EQID: 13JRDAUV0023

DATA CODE 1.3
ACTIVITY PKG NO. —
ENGR SYSTEM NO. —
QUAL. CLASS Q
Bechtel Log No. 13 10407

1 JORDA-UV-23		EG374-45		129		211		Q18	
TAG NO.		SUO NO.		ITEM NO.		MASTER VALVE MARK NO.		PROJECT CLASS	
UNITS 2 & 3 WILL HAVE PREFIX 1 & 3		ANCHOR/DARLING VALVE CO.		ARIZONA		PUBLIC SERVICE COMPANY		P.O. NO. 10407-13-PM-2218	
ALTO VERDE NUCLEAR GENERATING STATION				UNITS 1, 2 & 3					
C TAG NO. WAS 2JORDA-UV-23. TOL. ON 3068 BORE WAS ±.010		LBL 3-79		ANCHOR/DARLING VALVE COMPANY MAYNARD, CALIFORNIA					
B REV. MAT. FOR PARTS 100, 110, 111, 230F & 250S		LBL 3-79		3"-150* GATE VALVE, DBL. PACKING, CAST ST/STEEL - BOLTED BONNET, B.W. ENDS, MOTOR OPERATOR					
PART NO. 250B WAS PLUG. ADDED 56 & 230F 1/4 PITCH & LEAD WERE 1/6, ±.010 WAS ±.031, CHANGED ANSWER OF 3A TO NO., & 46 MIN. WALL WAS .22.		LBL 3-79		DATE: 10-5-78		SCALE: NONE		93-151-97	
A		LTL		REVISED		BY DATE		APP'D DATE	
129		211		Q18		10-6-77		-SUJ-5746-153

FWNGS **APS** REVISION (AR) TO SUPPLIER DOCUMENT

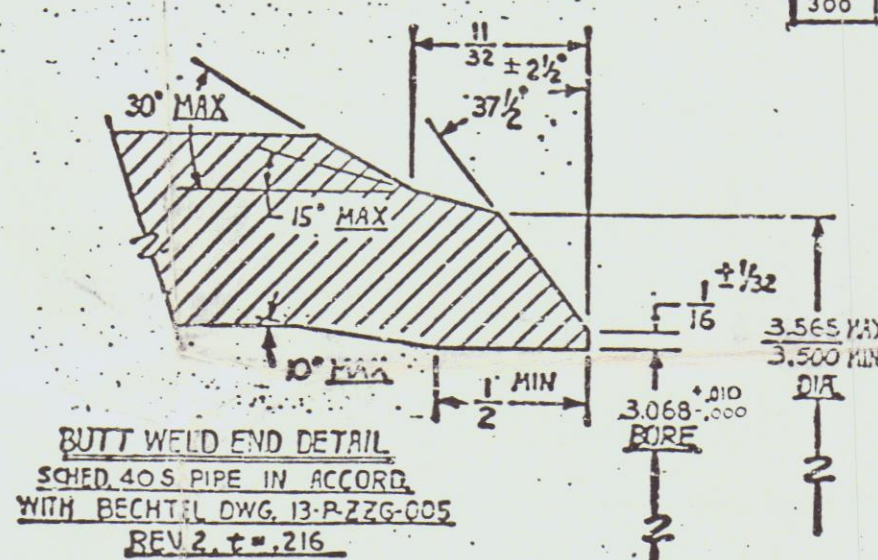
D	WEIGHT OF VALVE ASSEMBLY WAS 835, SHELL TEST PRESURE WAS 3250, SEAT TEST PRESURE WAS 2200, SEAT LEAKAGE RATE WAS 12	F M 9/ 20
---	---	--------------------

PACKAGE			AR		REVISION		NOTES		ORIG		CHECKER	RE	QA	
NO.	NO.	DATE			DESCRIPTION		SUB	STATUS						
AR 923	1	8-26-92			INCOMP SDCN #A09972. WHICH SUPD A07751		6	1	CAW	PB	-	-	-	
ARC 1302	2	6-30-95			INCOMP. EDC#94-00441		7	1	JA		-	-	-

CHK NO.	CHANGES/COMMENTS	NOTES 1 2	GS	PE	DATE
/	VENDOR IMPROVED CAPSCREW MTC FROM AISI 316 TO A316 A574 (ITEM 215B)	No 1			9/22/83
	PER VENDOR, INSTRUCTIONS CHANGE TO DEN C. MIC 18E986	()			
*	REF. A/DV TUEX 2/24/83 (DPR 112SPR0014)	()			
		()			
		()

DOCUMENT STATUS: ☒ REVISOR MAY PROCEED
